Evaluation of Aircraft Ejection Seat Safety When Using Advanced Helmet Sensors

**SUBJECT: Evaluation of Aircraft Ejection Seat Safety When Using Advanced Helmet Sensors
(Report No. DODIG-2015-090)**

SUBJECT: Navy Response to DoDIG Draft Audit Report on "Evaluation of Aircraft Ejection Seat Safety when using Advanced Helmet Sensors", D2014-DT0TAD-0002.000, Dated 12 January 2015

Figure 7. Air Force Ejection Injury Level by Speed

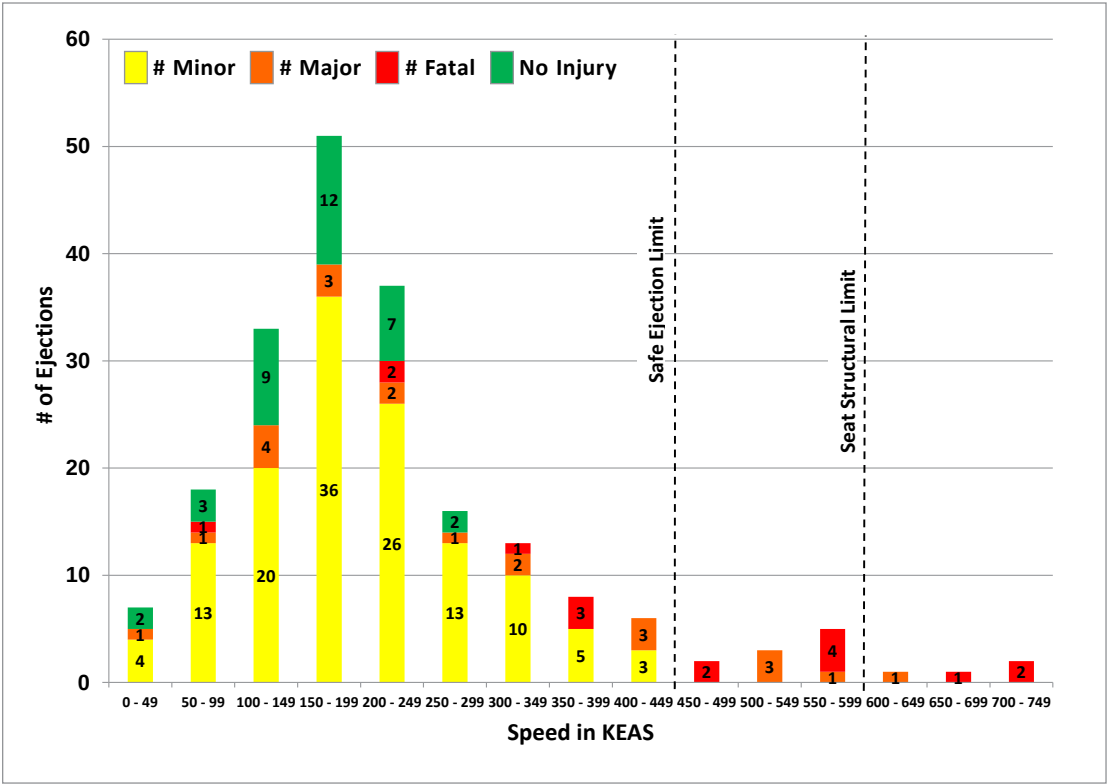
Page 12, Figure 7: It is very difficult to distinguish Major (orange) from Fatal (red). For some odd reason, it is much easier to do so in Figure 9.

Revised
